THE ILLINOIS STATE TOLL HIGHWAY AUTHORITY

BASE SHEETS

ESC (200), RDY (400), BRG (500), DRN (600), MOT (700), OHS (720)

PART 1 of 2

VERSION: 2026-03	BASE SHEET: M-BRG-531	SHEET: 1 OF 4
---------------------	--------------------------	------------------

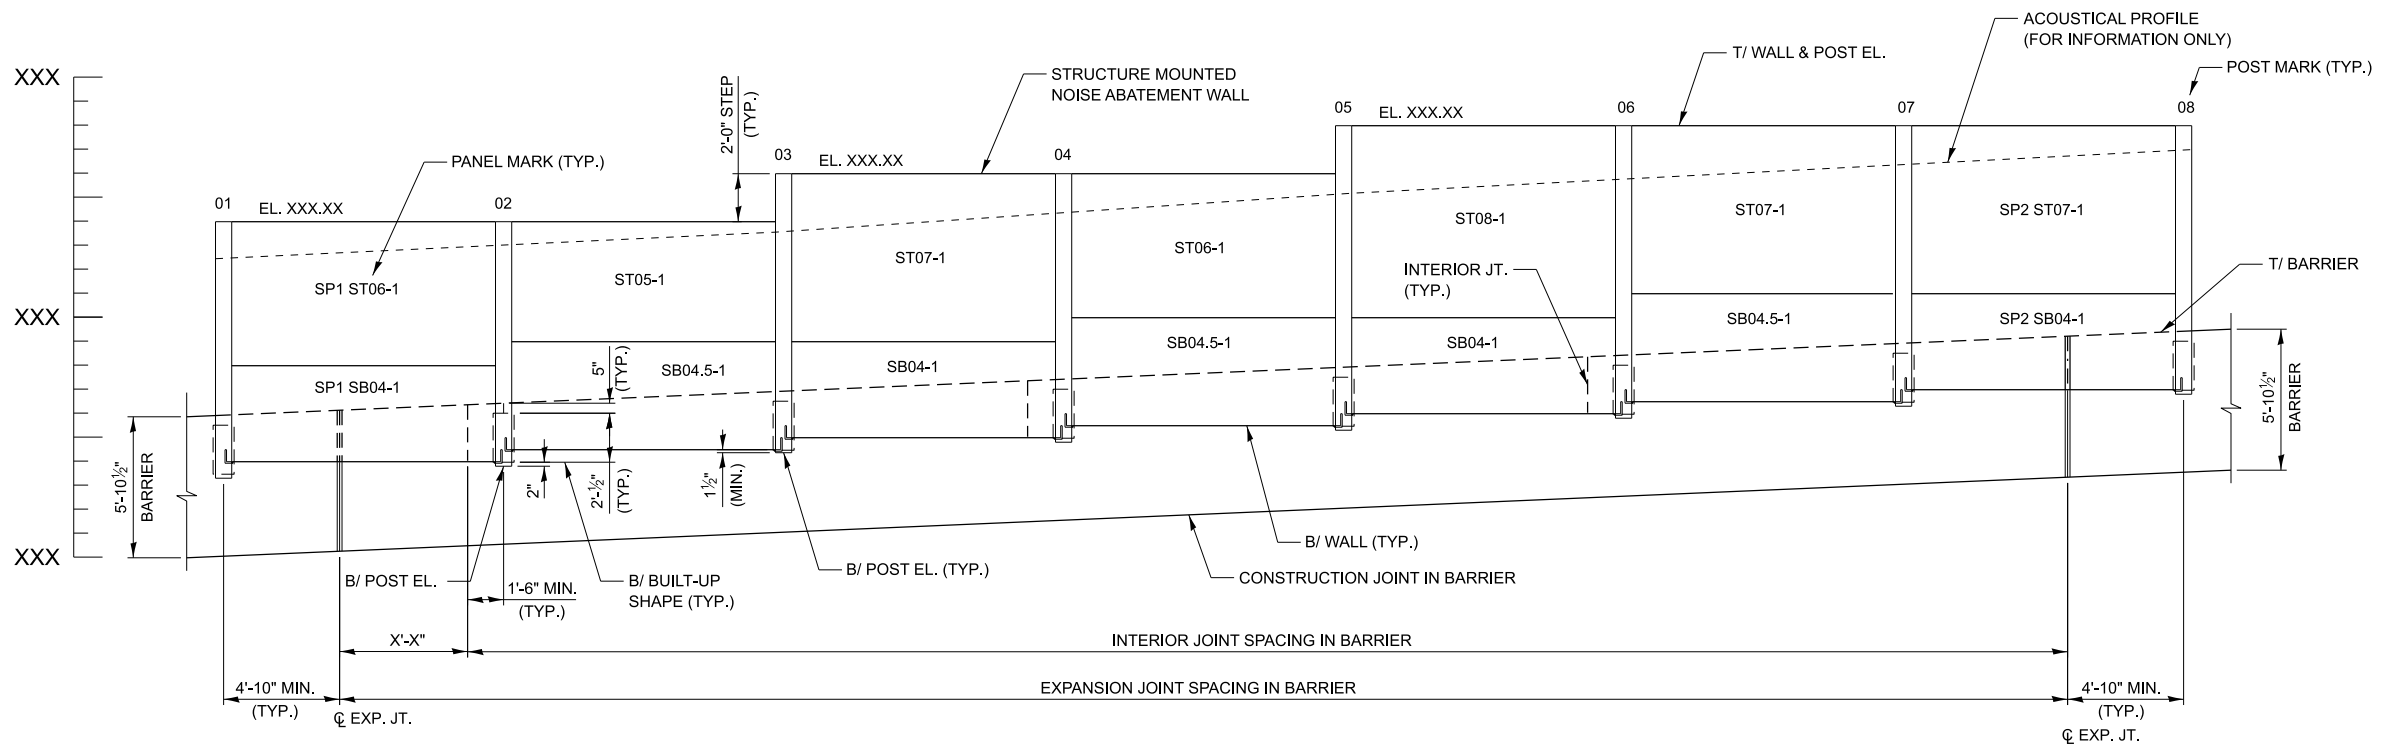
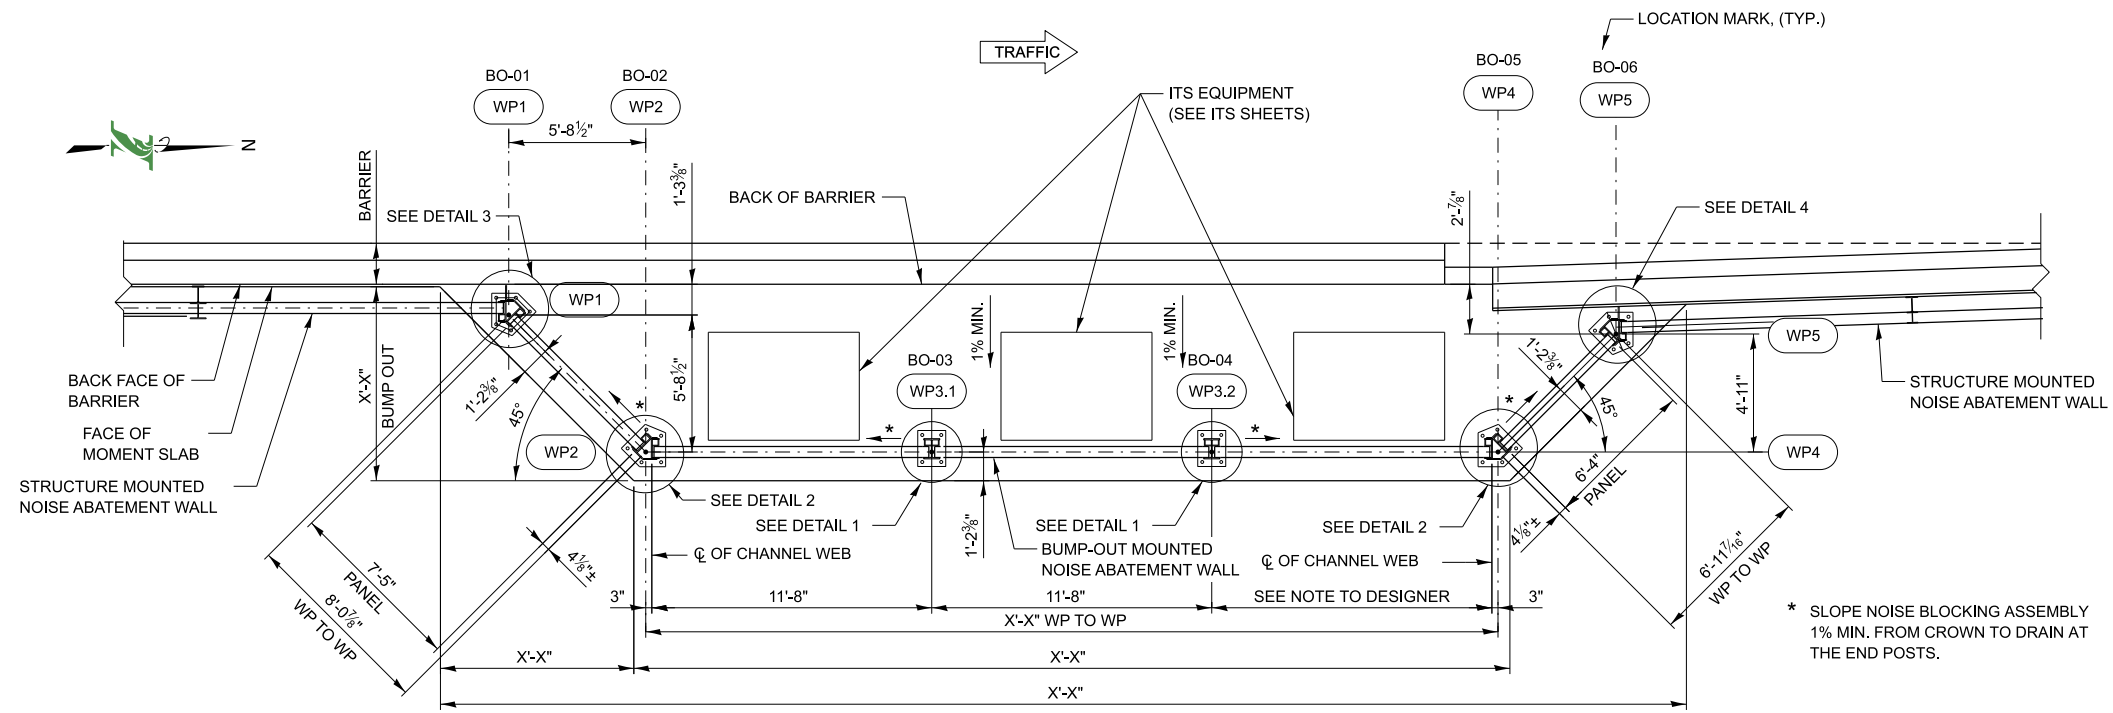
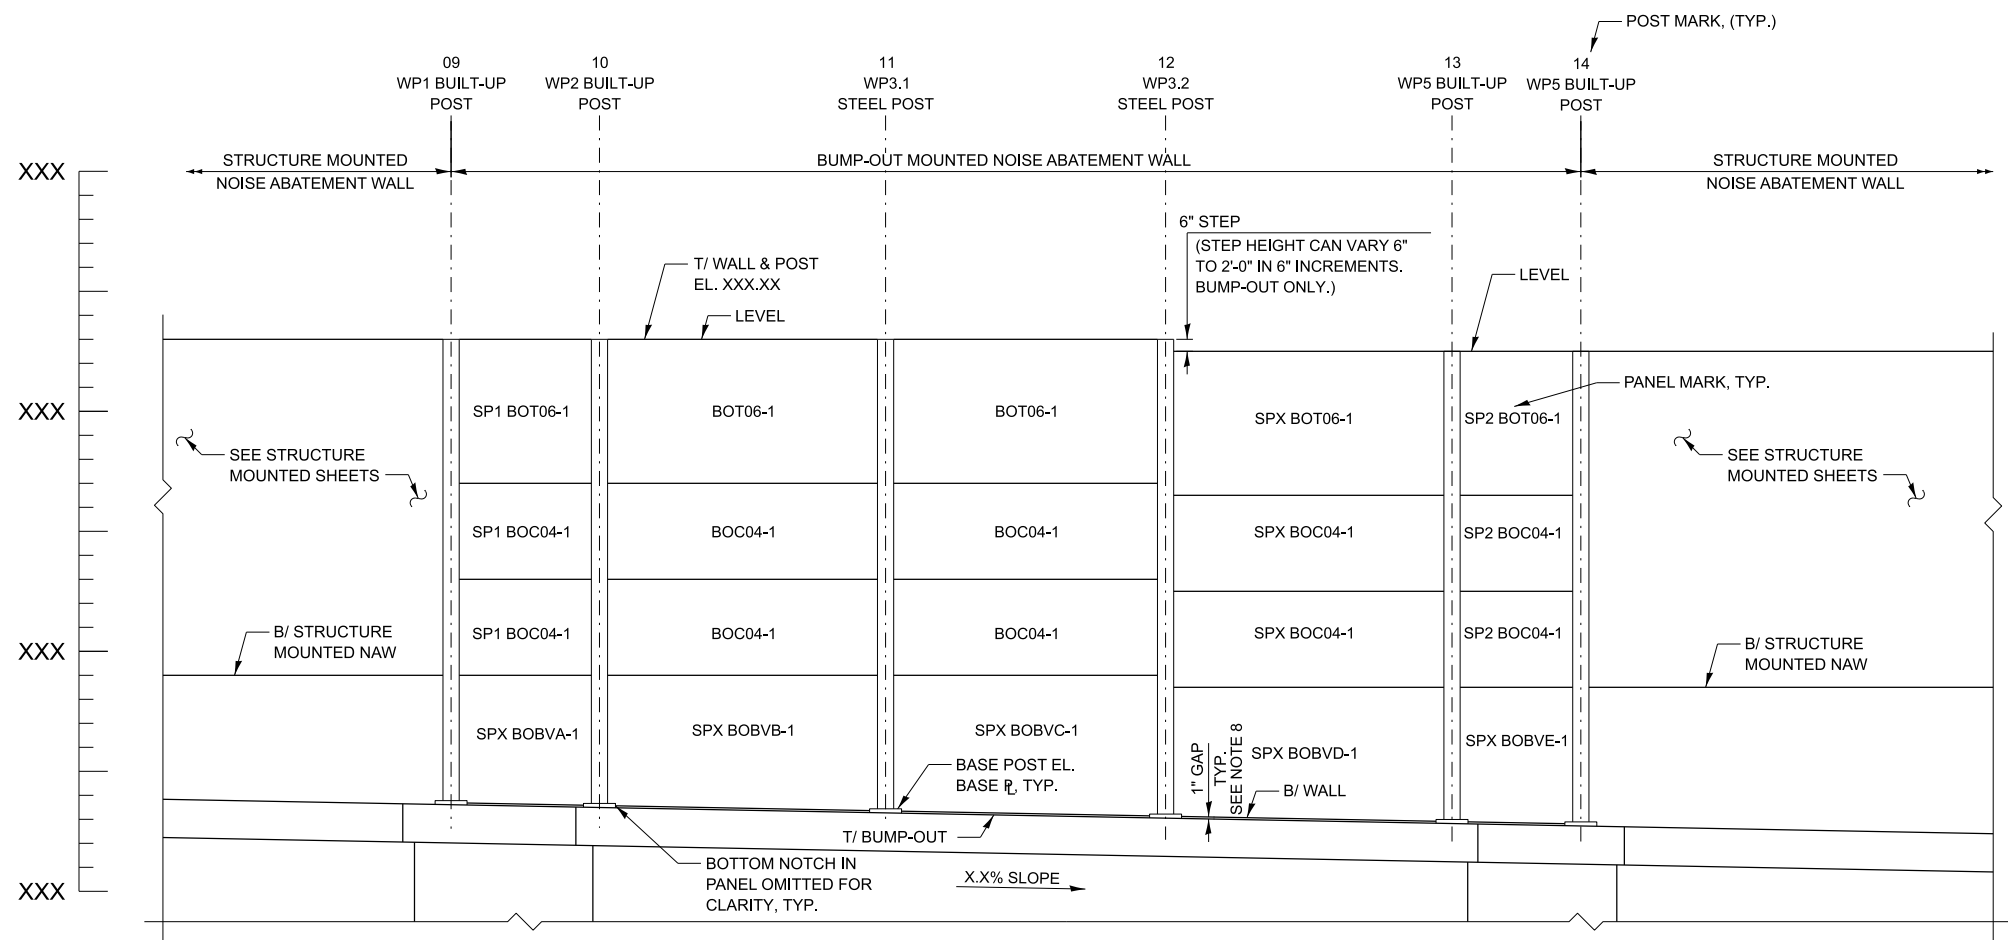
Section M	Base Sheet Drawings	
	Drawing	Modification Summary Effective: 03-01-2026
	Bridge (BRG)-Series 500	
	M-BRG-531	BUMP-OUT MOUNTED NOISE ABATEMENT WALL COVER SHEET
	Sheet 2	Detail 3 callout added and Bent Plate added in Detail 3 and 4. Note revised to include Detail 3 and 4.
